Bury College HI+STEM

Courtyard Redesign

BCS-ITR-00-XX-RP-L-0010

June 2022

PROJECT TITLE				
BURY COLLEGE - HI+STEM				
DRAWING TITLE				
PHASE 1 LANDSCAPE REVISED COURTYARD OPTION				
SCALE	DRAWN BY	DATE		
1:200@A1	MS	JUN '22		
JOB/DRAWING NUMBER		REVISION		
BCS-ITR-00-XX-SK-L-0002		P01

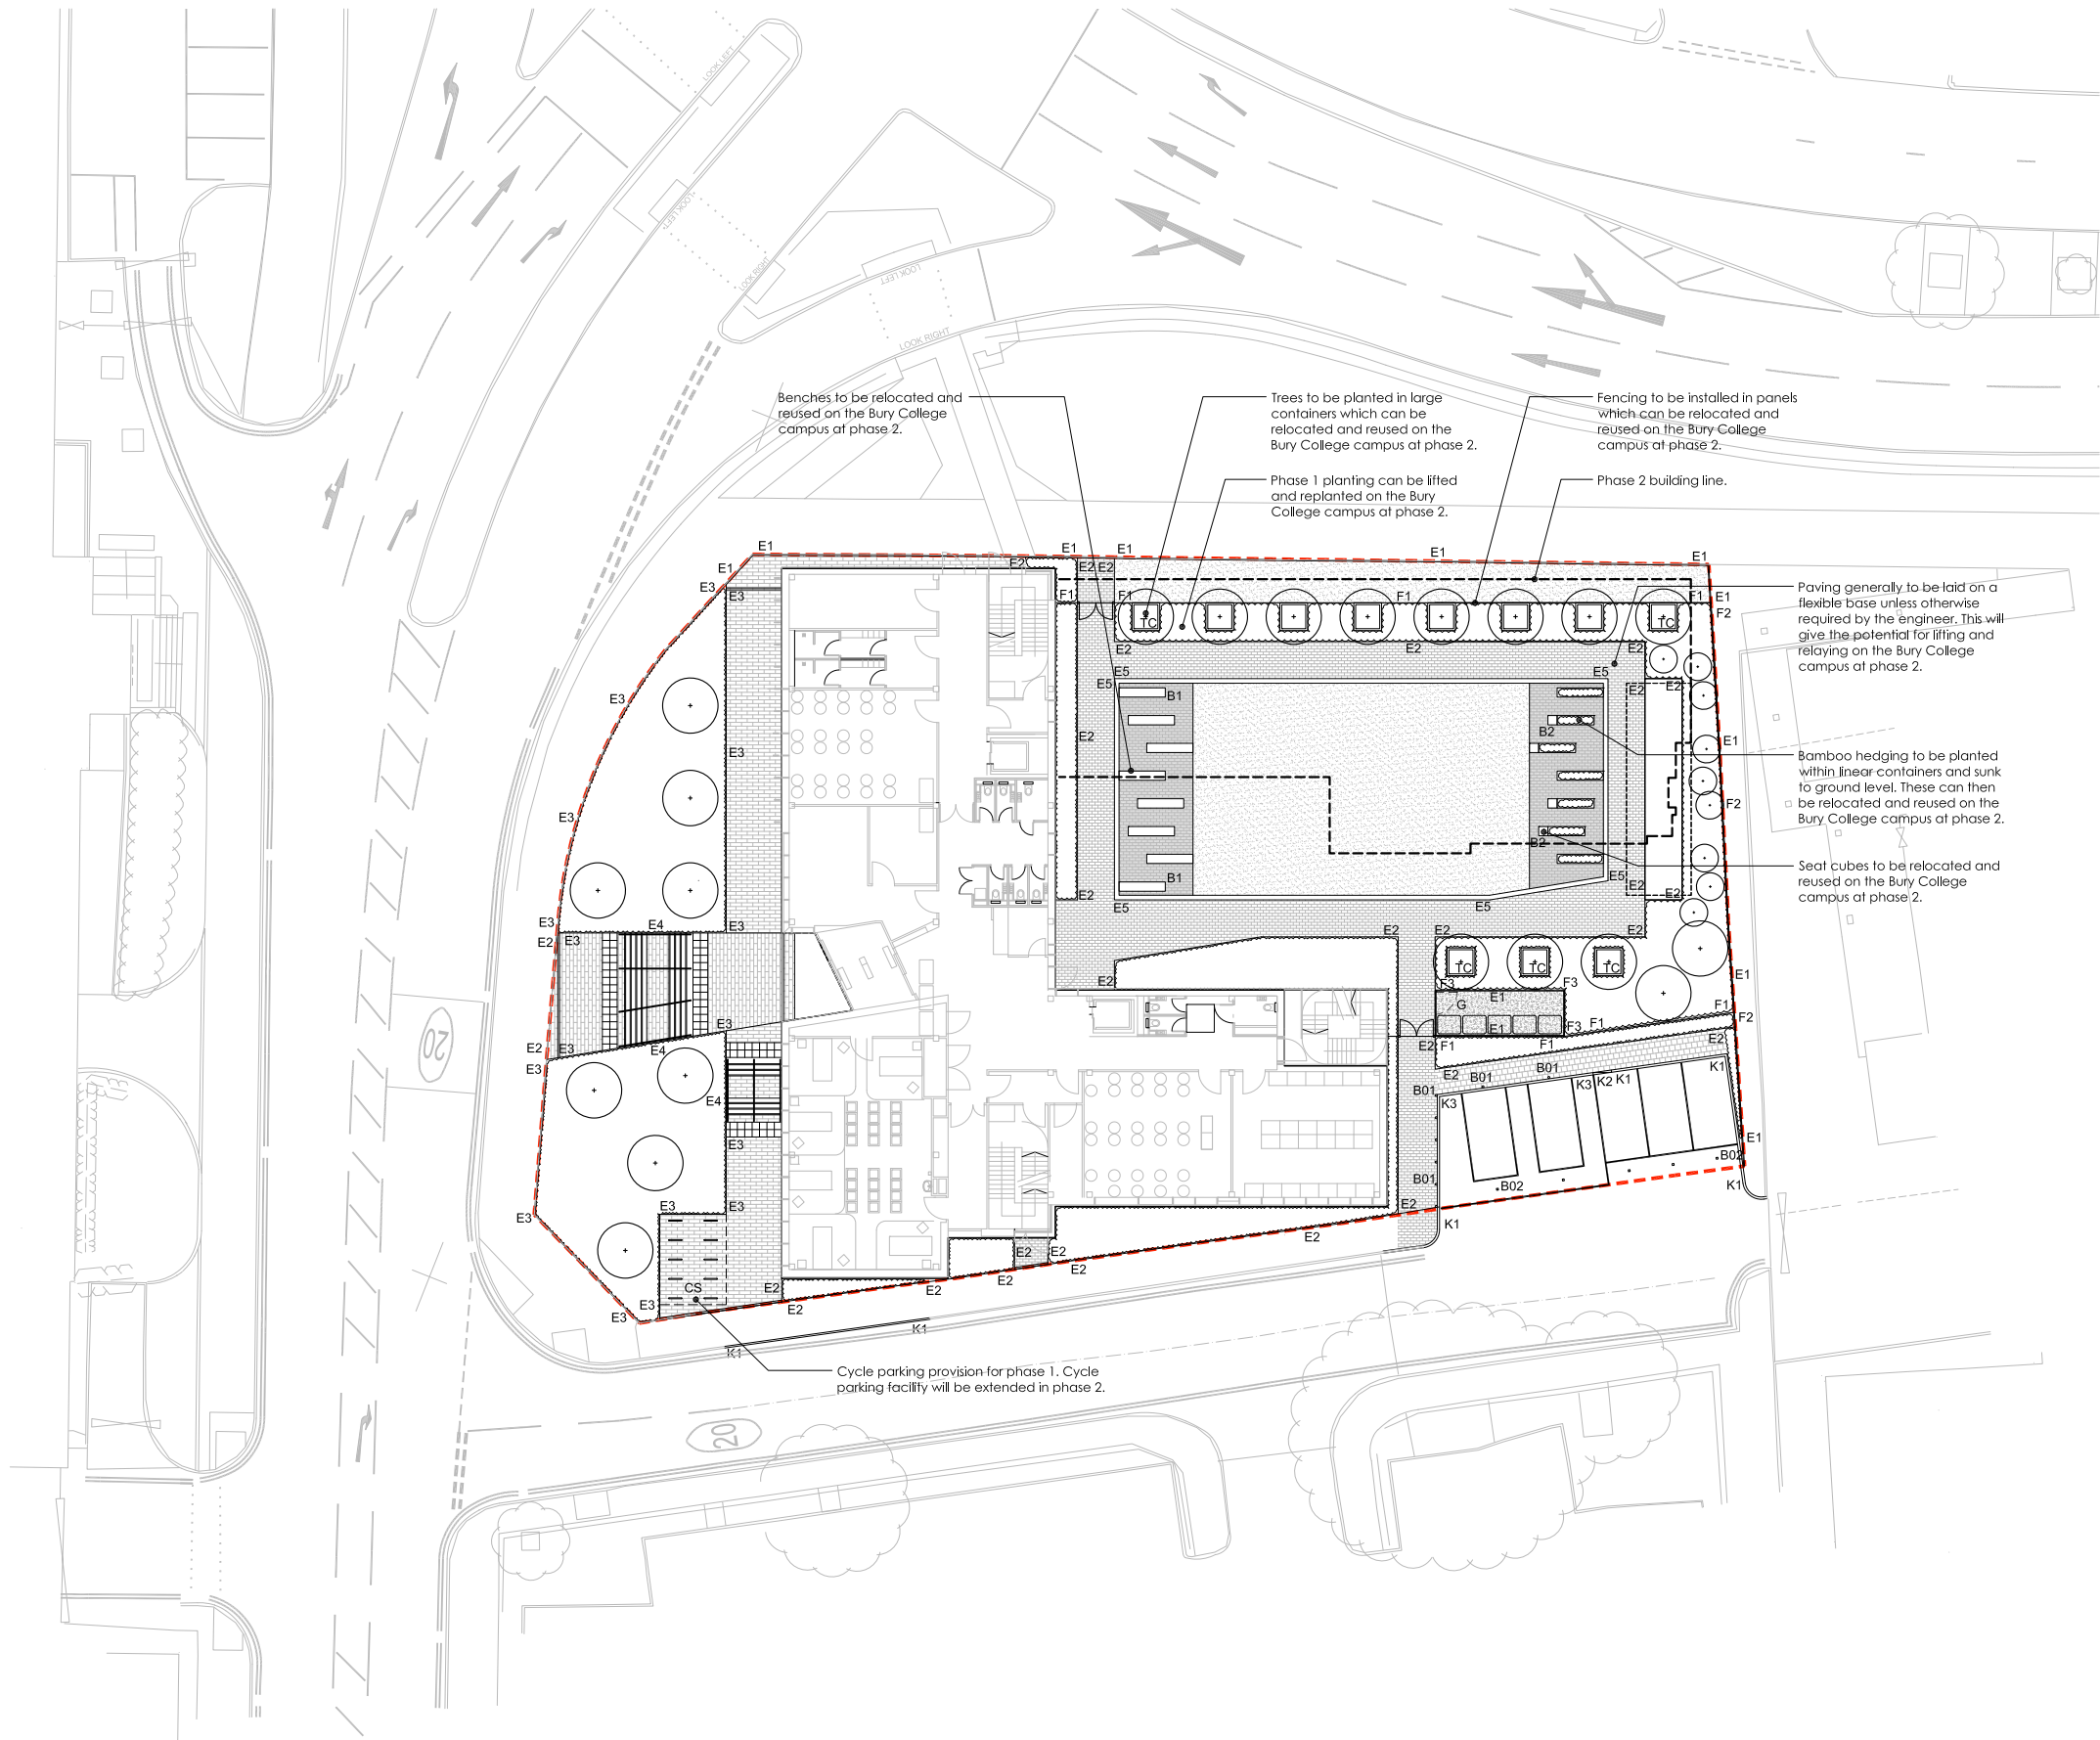
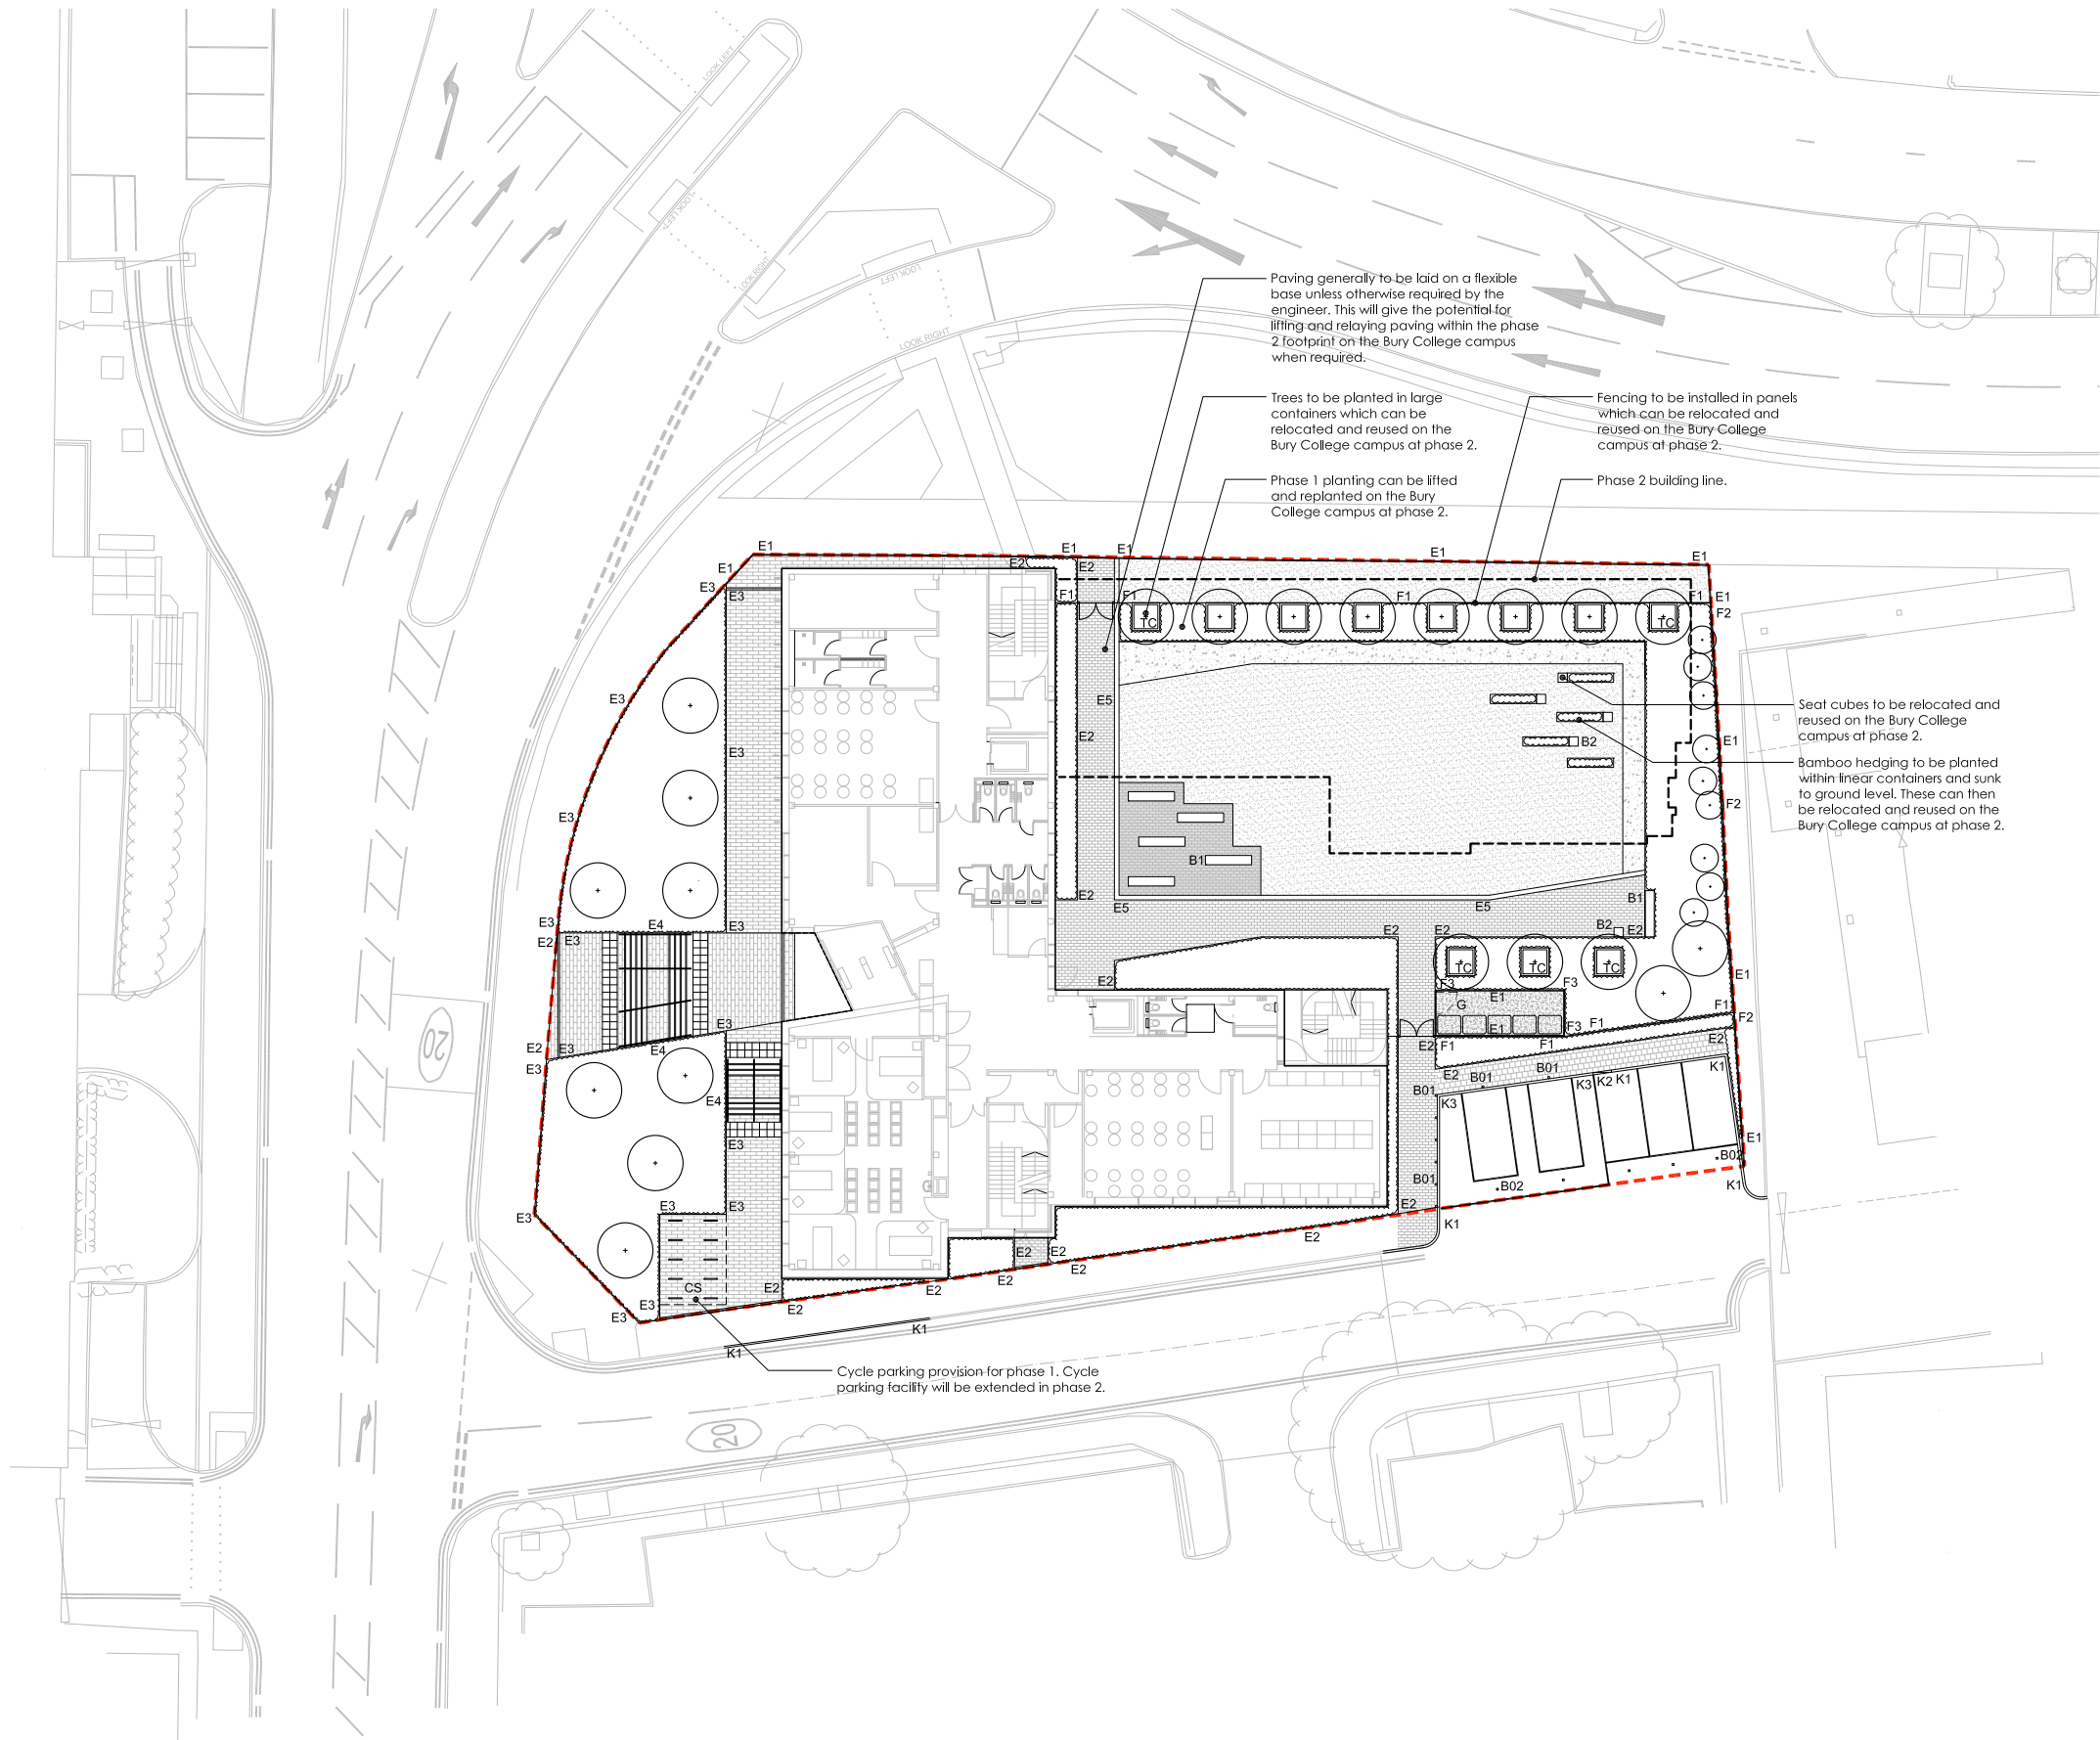
NOTE:
This drawing details the phase 1 landscape works which will be implemented in line with phase 1 of the HI+STEM building programme.

The phase 2 building extension is highlighted on the plan to highlight interfaces between phase 1 landscape works and the future phase.

This drawing also notes how we expect materials and furniture will be reused / relocated when phase 2 works are undertaken.
